Urgent Field Safety Notice

10819177, Rev. A

ADVIA Centaur®
ADVIA Centaur® XP

Improper Manual Loading of Sample Racks

Figure 1. Sample Entry and Inprocess Queues

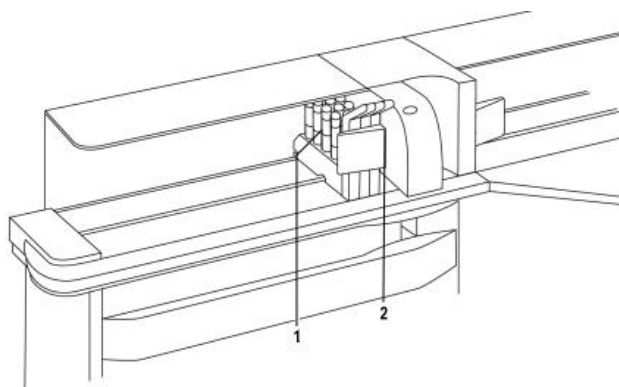
Pushing the sample racks may cause misreads of Sample IDs (SID) if the sample rack loading instructions are not followed exactly as described in the ADVIA Centaur or ADVIA Centaur XP Operator's Guide. Refer to Figure 1 in the Actions to be Taken by the Customer section.

If a sample rack is manually pushed with a slight forward nudge to the entry position without placing it on the rack positioning guide, the barcoded tube SID can be assigned to different positions in the rack. This may lead to misreported results.

When loading a sample rack, ensure the sample rack notch rests on the raised area of the sample entry queue (1) and the system automatically moves the rack to the loading position. This raised guide ensures the sample rack is positioned correctly and will accurately scan each barcode as it enters the inprocess queue (2). **Do not** push the sample racks into the system.
